Squeezer Angle Control Signal Pickoff

D1700309-v2 R. Abbott, D. Sigg, L. Sanchez

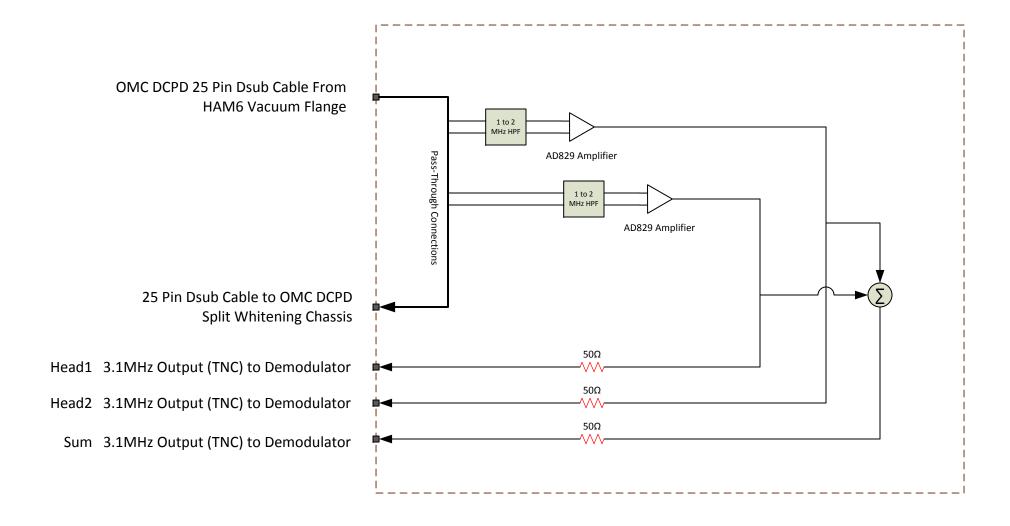
$V2-Added\ design\ updates\ per\ conversation\ with\ Daniel\ Sigg\ including\ reordering\ stages\ and\ the\ desire\ for\ gain\ in\ the\ 3.125MHz\ signal\ path$

- 1. 3.1 MHz was chosen as the highest frequency signal that can be transmitted with decent SNR through the existing OMC DCPD
- 2. The purpose of this chassis is to split off the 3.1 MHz signal from the normal DCPD path without introducing noise.
- 3. The desire is to have a gain of ~10 at 3.125MHz from the differential OMC DCPD signal being sampled, to the TNC RF outputs
